MULLEADY'S LTD

WL Ref: 169-1

Re: **Technical Amendment - Mulleady's Ltd., Cloonaugh, Drumlish, Co. Longford**

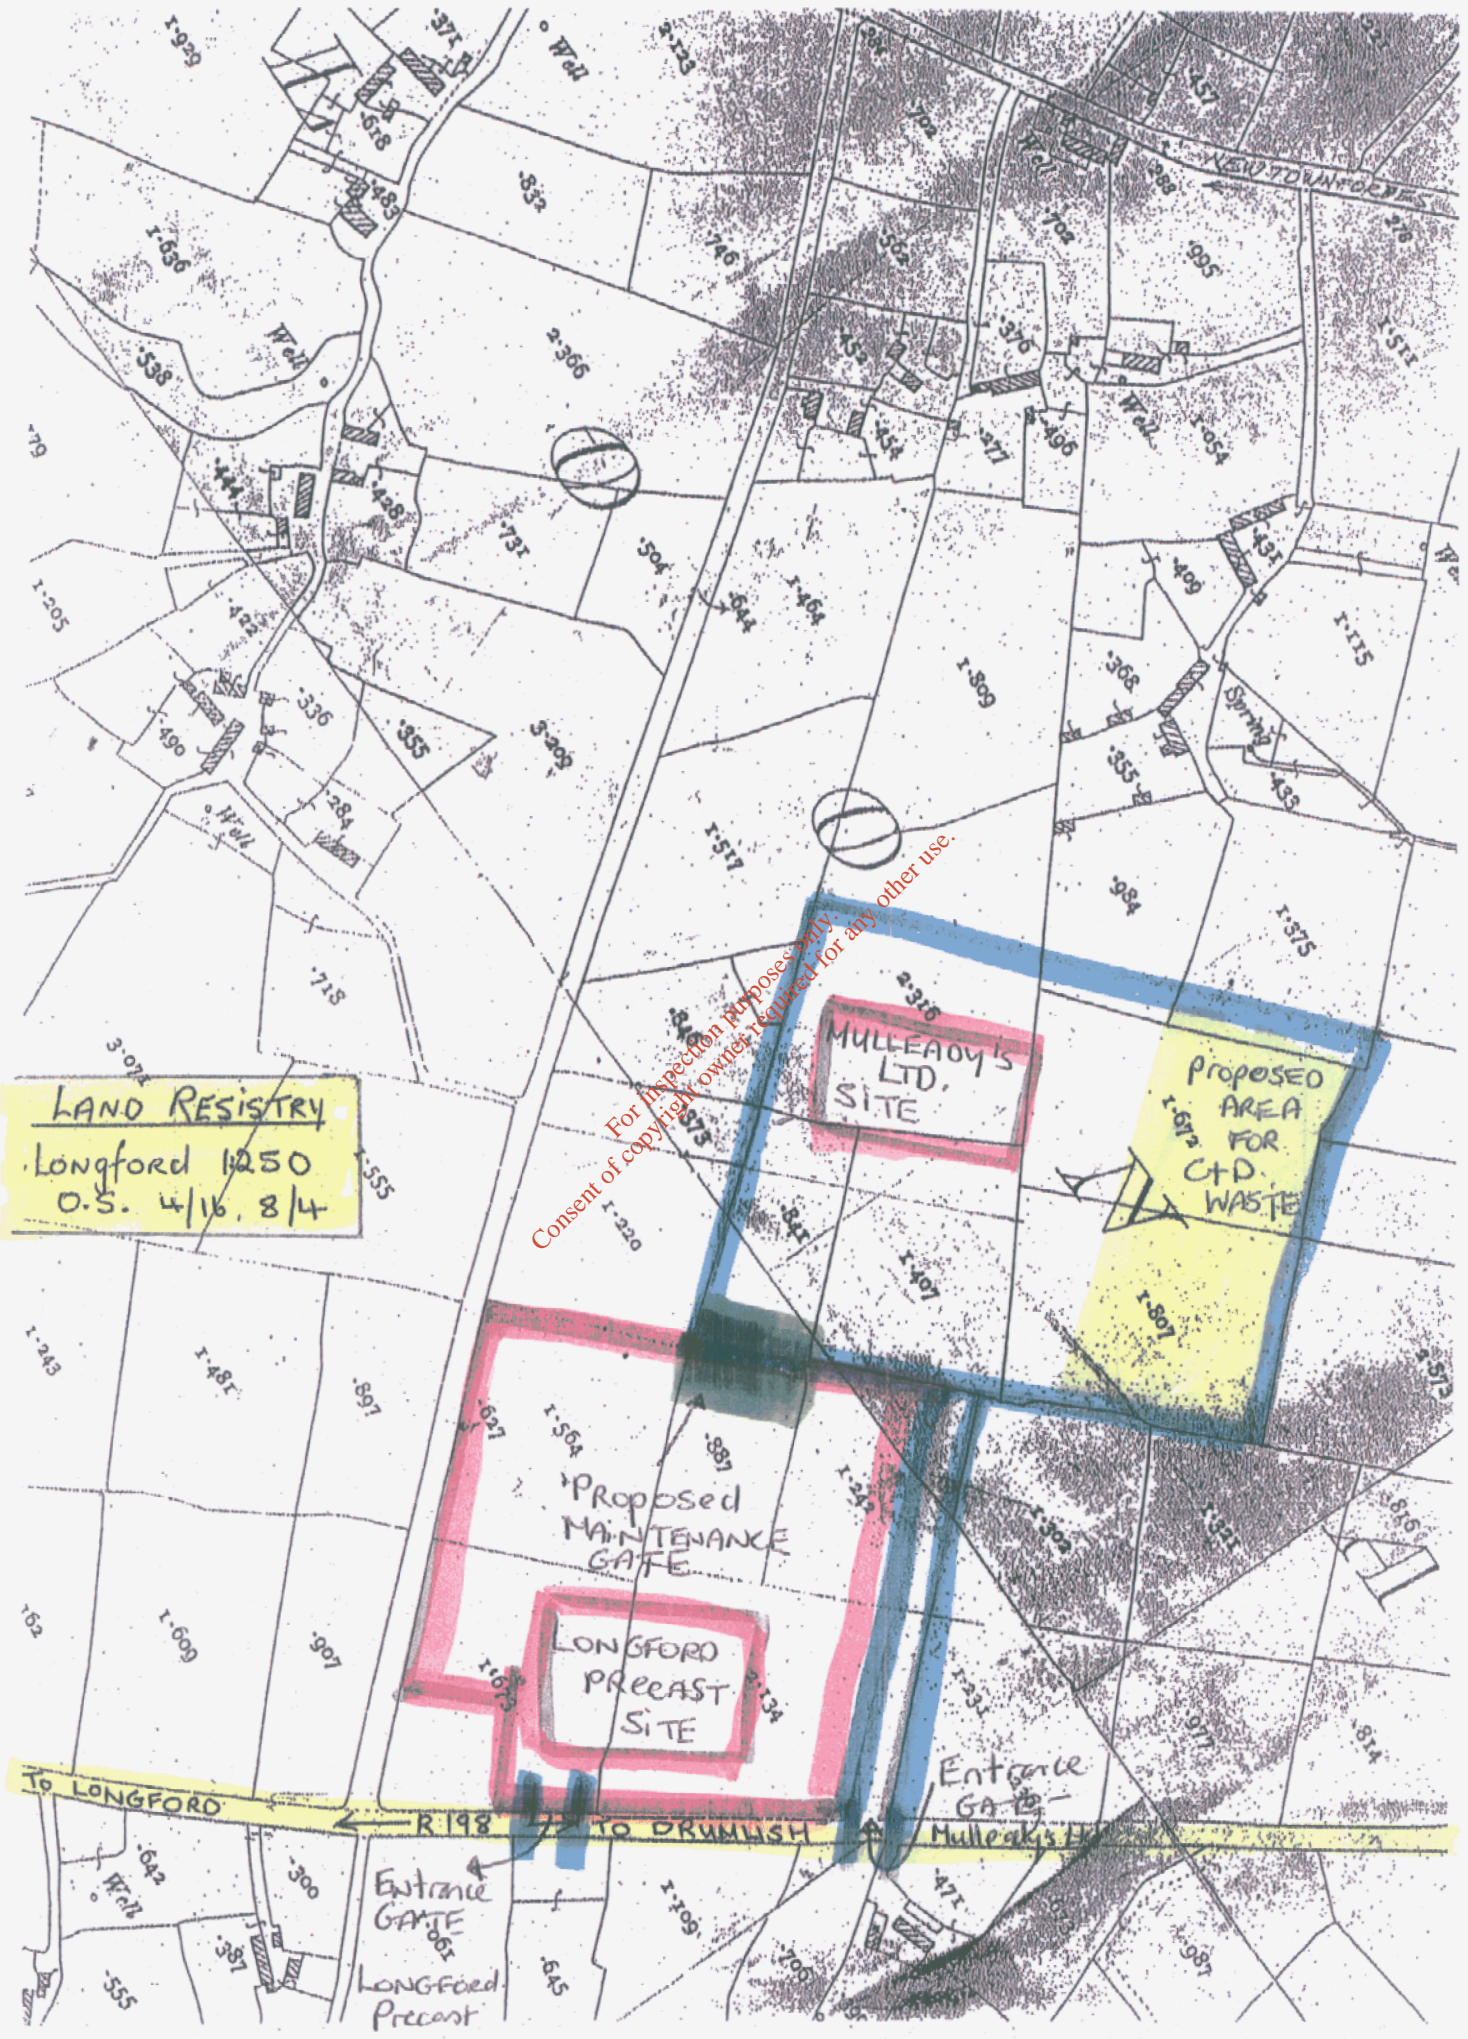
- Emergency Driveway Access to adjoining Precast plant for Recycling Plant and Vehicle Repairs.**

Longford Precast is a sister company adjoining Mulleady's Ltd. waste management facility. Within Longford Precast is an engineering department and a garage. Longford Precast is contracted to carry out all maintenance work on all our plant, both static and mobile on our site.

It is a major inconvenience and a high risk health and safety issue removing mobile plant out onto the R198 crossing the line of traffic coming from Longford utilising the main facility entrance. Whether the vehicle or mobile plant is driven or towed it has to travel 100 metres from the waste facility entrance to enter the Precast facility. The vehicle has to cross the line of traffic coming from Longford again to enter Longford Precast Ltd. yard (sketch enclosed confirming this route).

We have suggested to Mr. Kealan Reynolds (Inspector) at the EPA Castlebar office that we would like to propose to fit an electrically operated sliding gate incorporating a personnel gate within it. This gate would be opened and closed by a remote control fob which would be operated by select staff and opened for maintenance purposes only.

Regarding C&D waste our site is quite low on the Northern side and requires raising up the ground by approximately 1 metre to bring it up to existing concrete levels. The material we propose to use would be all inert clean material from our waste collection activities. We propose to use clean waste concrete blocks, bricks, waste concrete and subsoil etc.
